**Staff Report for Planning Board**

**Project Summary –Major Site Plan and Architectural Design Review  
Determination of Completeness**

Project: Capital City Subaru – Major Site Plan (2026-044)  
Property Owner: Two Wheeler Holdings, LLC  
Applicant: Wilcox & Barton, Inc.  
Property Address: 110 Manchester St  
Tax Map Lot: 782Z 44

**TO:** Alec Bass, Assistant City Planner  
**FROM:** Paul Gildersleeve, PE, Project Manager and Pete Kohalmi, PE, Associate Engineer  
**DATE:** May 8, 2026  
**SUBJECT:** Site Improvement Plans- Major Site Plan Application  
Engineering Review  
110 Manchester Street; Map 782Z, Lot 44, City Project 2026-044

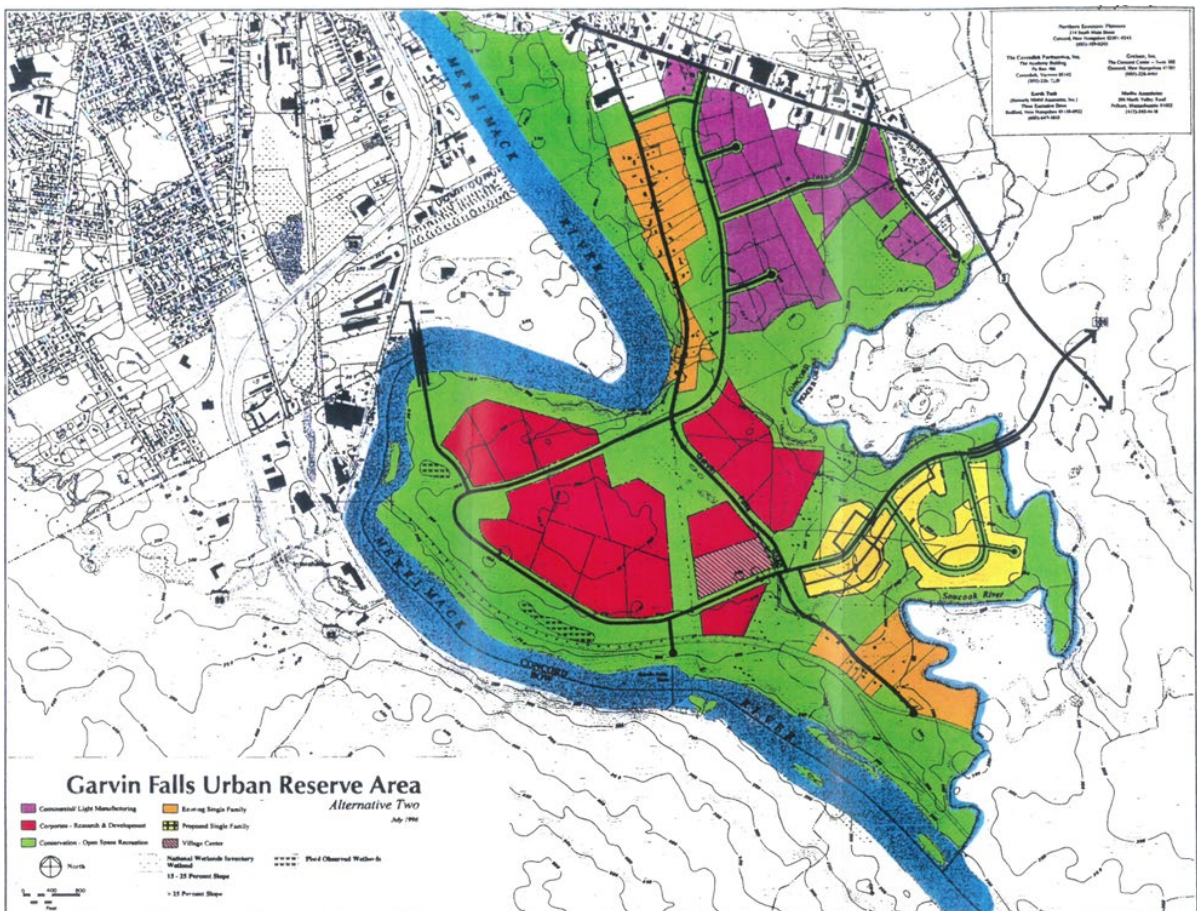
This study estimates between 12,000 to 15,000 jobs in the developable portion of the Garvins Falls Urban Reserve study area. To accommodate this future development, the study proposed a roadway network to serve the development area. As property has developed in the Manchester Street corridor, the City is desirous of obtaining property rights, through easements or other agreements, to accommodate the future roadway network to serve the Garvins Falls Urban Reserve area (see below).

City staff proposes to work with the applicant through this current application to provide for future access to the Reserve area and requests that the Planning Board include provisions for this as part of any conditions of approval associated with the project. Additionally, coordination of these efforts should also consider access to the Reserve area associated with recent applications
